INDESIT company

MBA45D3NFA

F034591

RE0224T0 Exploded views

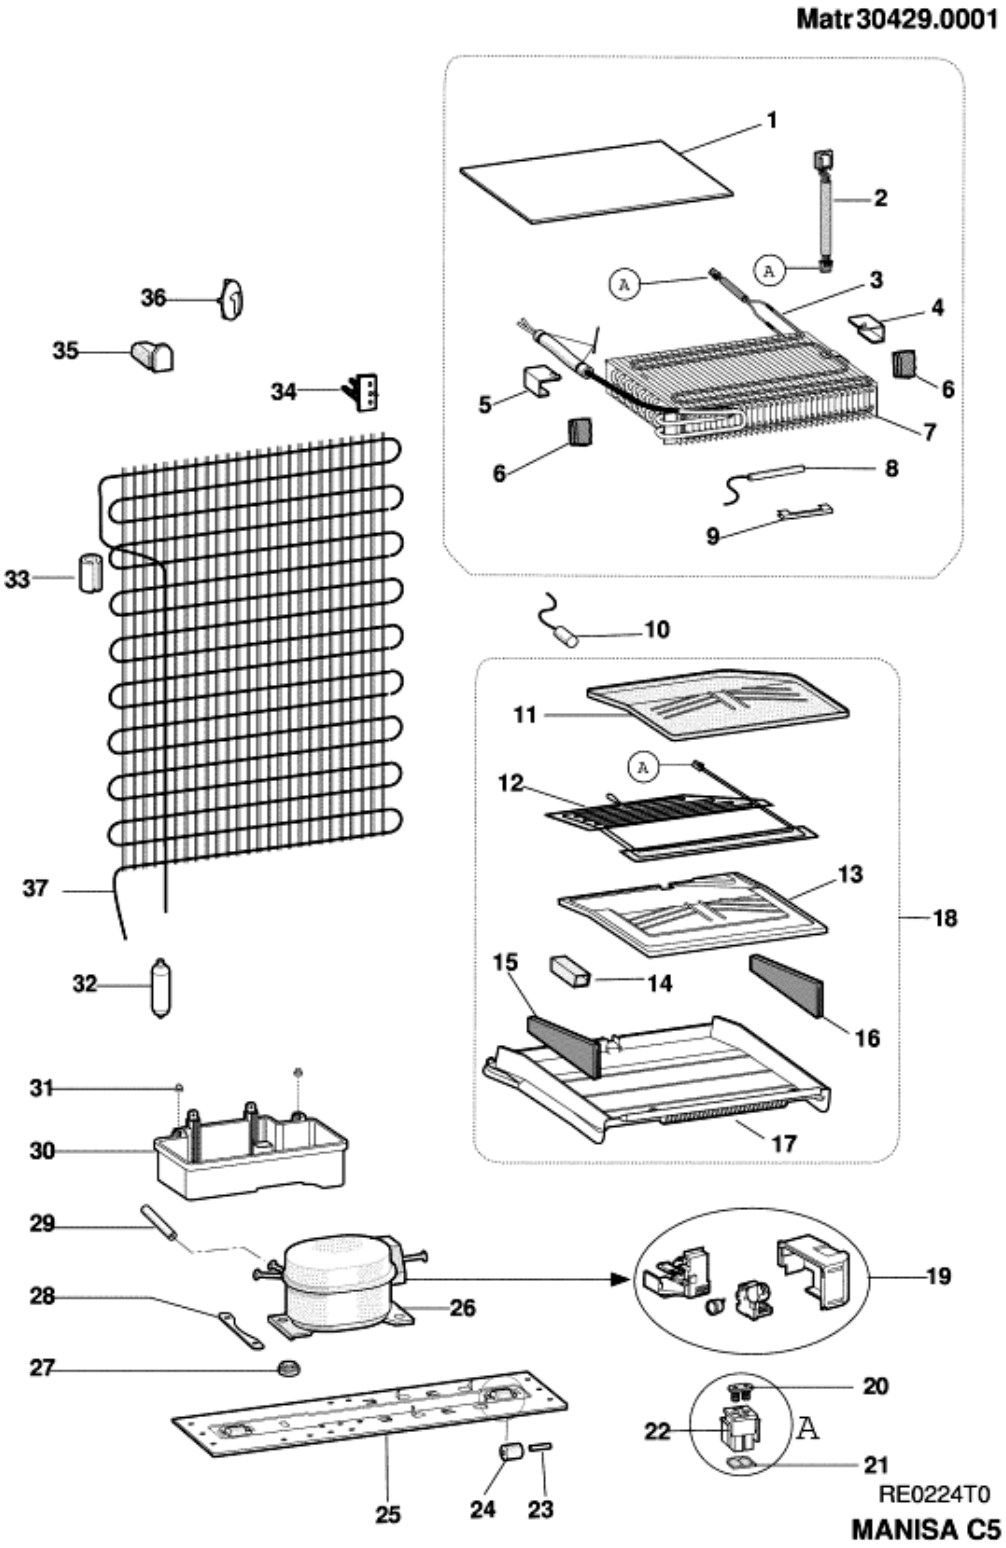
0999376: ICE FORMATION AT THE BACK OF THE EVAPORATOR

Below modifications have been performed to prevent ice formation at the back of the evaporator on L70 combies. These new parts can be supplied as an assembly C00141277
1- Spugnetta evaporatore left and right have been modified since 12/08/2005. Spare part codes remain the same (C00094468-C00094467). These parts must be replaced together in case of necessity of the replacement.

2- Power of the rezistance for divisorio camere has been increased from 40W to 50W since 03/10/2005. Spare part code remains the same (C00095774).

3- Power of the rezistance for evaporator has been increased from 140W to 150W since 26/09/2005. Spare part code remains the same (C00115199).

4- Drain hose end piece C00141278 has been used for draining the water to the evaporating tray since 26/09/2005.

These new parts can be supplied as an assembly C00141277.(TB001014 - ex.TECHNICAL NEWS STN-CL 0511.1)

RE0225T0

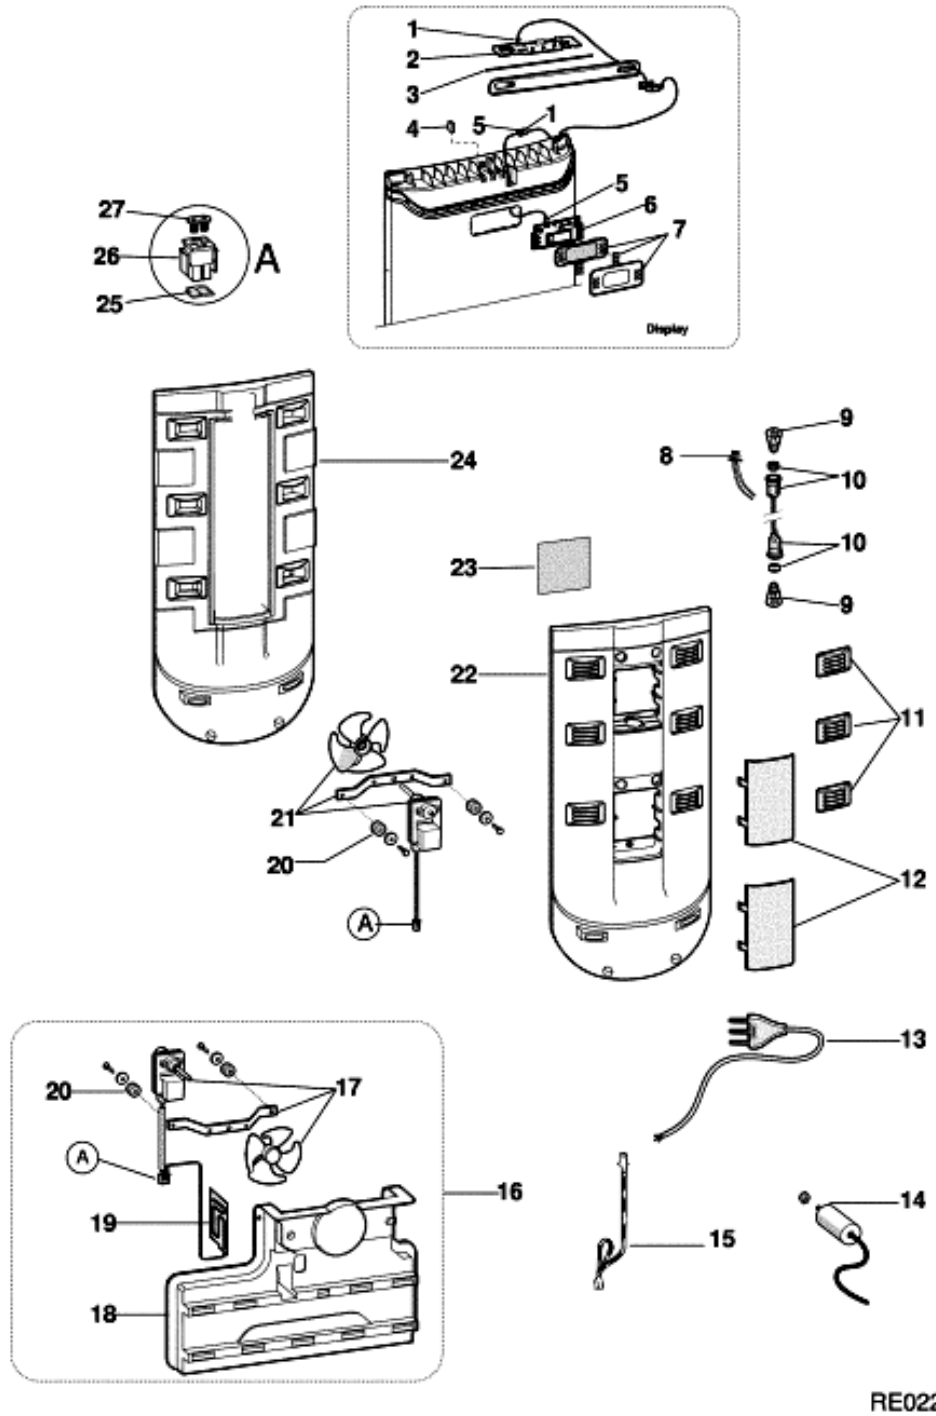
5- Fan motor plastic assembly has been modified. The hole for propeller has been modified to prevent friction between propeller and fan motor plastic since 03/10/05.
Spare part code remains the same (C00116498).

0999379: TWO HOLES HAVE BEEN CANCELLED ON MULTIFLOW FOR COMBIES

Due to low temperature at the lower part of the fridge section on Manisa combies two holes which are placed on multiflow cover have been cancelled for all combies since 13/04/2006.
